## Microcontroller Technical Information

RX78K0R 78K0R Real-Time OS  Document Modifications	Document No.	ZBG-CD-08-0053	1/1
	Date issued	December 17, 2008	
Related documents RX78K0R Functionalities: U18317EJ2 (2nd) RX78K0R Internal Structure: U18318EJ2 (2nd) RX78K0R Task Debugger: U18454EJ2 (2nd) AZ78K0R System Performance Analyzer: U18802EJ1 (1st)	Issued by	Development Tool Solution Group Multipurpose Microcomputer Systems Division Microcomputer Operations Unit NEC Electronics Corporation	
	Notification classification		Usage restriction
			Upgrade
		√	Document modification
		Other notification

## Modifications in RX78K0R User's Manual

Figure 10-2 Multiple Interrupts

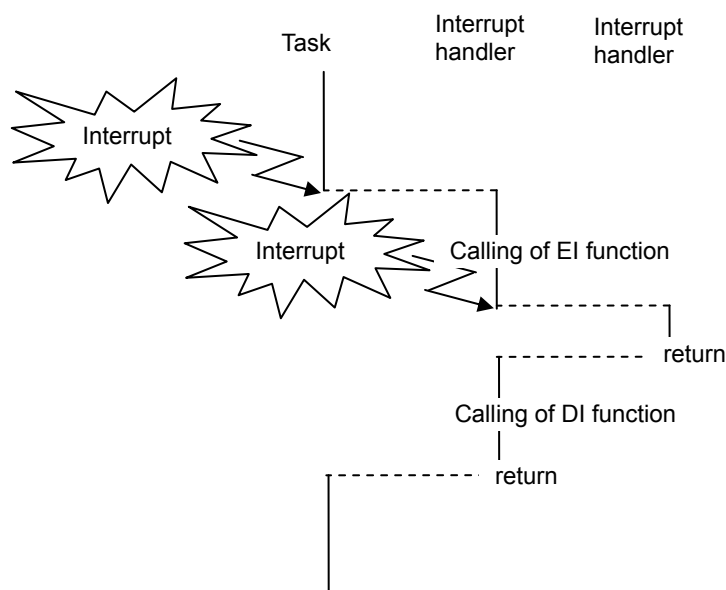
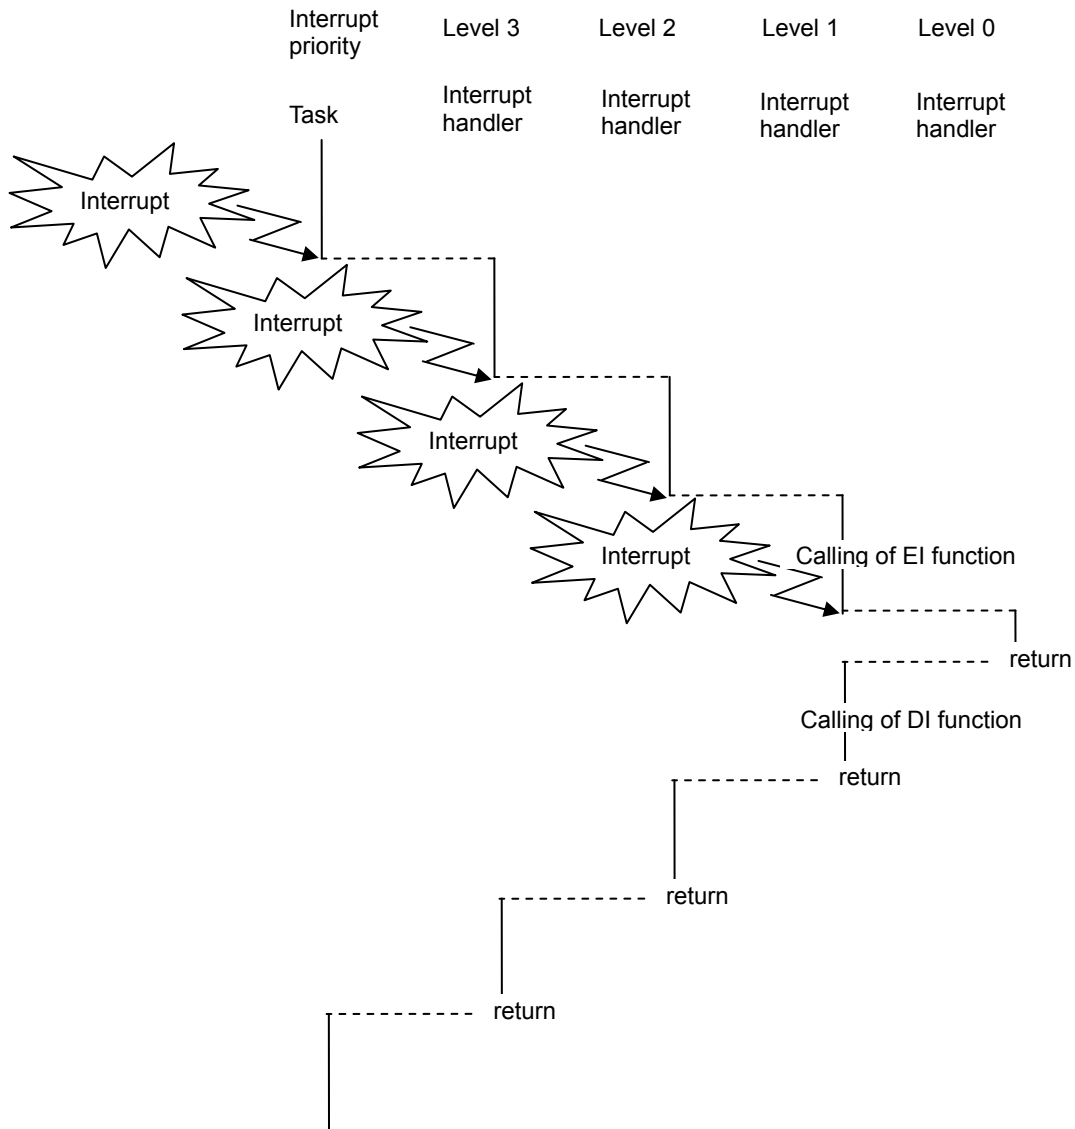
(2) 10.4 *Multiple Interrupts* on page 103

Calling of the EI function, which was required for generating multiple interrupts, is no longer required.

Before change:

The reoccurrence of an interrupt within an interrupt handler is called "multiple interrupt". However, since acknowledgment of a maskable interrupt is prohibited in the RX78K0R when control is passed to an interrupt handler, in order to create multiple interrupts, it is necessary to explicitly change the interrupt state within the interrupt handler (enable: #pragma EI directive code and EI function call).

After change:

The reoccurrence of an interrupt within an interrupt handler is called "multiple interrupt".

When control moves to an interrupt handler, then the state changes to acceptance of maskable interrupts enabled ("IE = 1"). For this reason, multiple interrupts are generally accepted from interrupt handlers. Multiple interrupts are likewise accepted from timer interrupts and cyclic handlers called from them.

When control moves to an interrupt process, then the state changes to acceptance of maskable interrupts disabled (because the RX78K0R does not mediate, the behavior is in accordance with that of the 78K0R microcontroller). For this reason, multiple interrupts are generally not accepted from interrupt processes. To enable the acceptance of multiple interrupts, it is necessary to call the EI function from the interrupt process. It is not allowed to accept multiple interrupt handlers from an interrupt process, and behavior is not guaranteed if this occurs.

If a user application enables multiple interrupts, then it is necessary to set the interrupt level of the interrupt handler/process as shown below.
